April 28, 2026

Product Update to 3/24/25 announcement – New Universal Leg for Freedman Type-2 Seats (3-Point)

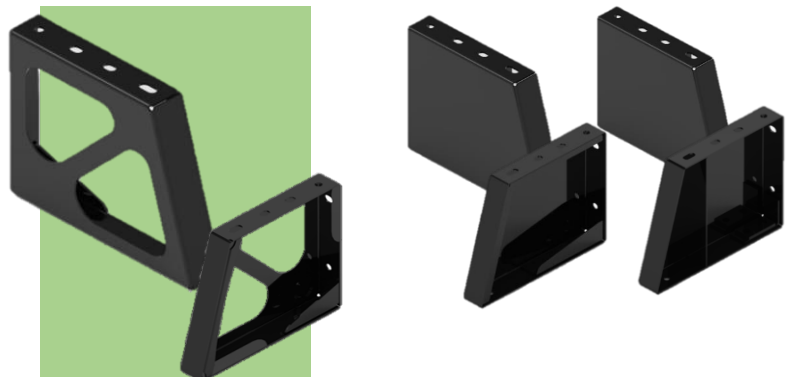
Our new Universal Leg is crafted from high-strength steel, is lighter, more versatile and visually pleasing without compromising performance. The new Universal Leg for Type-2 seating **replaces** both GO and 3PT leg systems. We've observed comparable or superior performance in FMVSS 207/210 tests for the new Universal Leg vs. your current GO or 3PT legs. Test reports are available upon request.

New U-T-2 Leg	GO Leg (Being replaced)	3PT Leg (Being replaced)
Part Number Curbside	107566	24021	14507
Part number Streetside	107567	13299	14508
Weight	6.0 lbs.	6.0 lbs.	9.3 lbs.

- The new leg system is now compatible with aluminum track flooring systems. Floor holes are on 1" increments AND have a slot to accommodate our 1.75" legacy rear holes spacing.
- 3+ lbs. weight savings from legacy 3PT legs.
- One leg for all Freedman 3-Point seats means you can swap legs if you need to.
- Easier accessibility during installation to vehicle.

- All new orders for type-2 seats will default to the new Universal Legs (when applicable) in late June or early July 2026.
- We will attempt to fill existing orders so that multiple unit runs do not have varying leg types.
- Replacement parts will continue to be available.
- As of today, Family 3PTA seats are not part of this change.
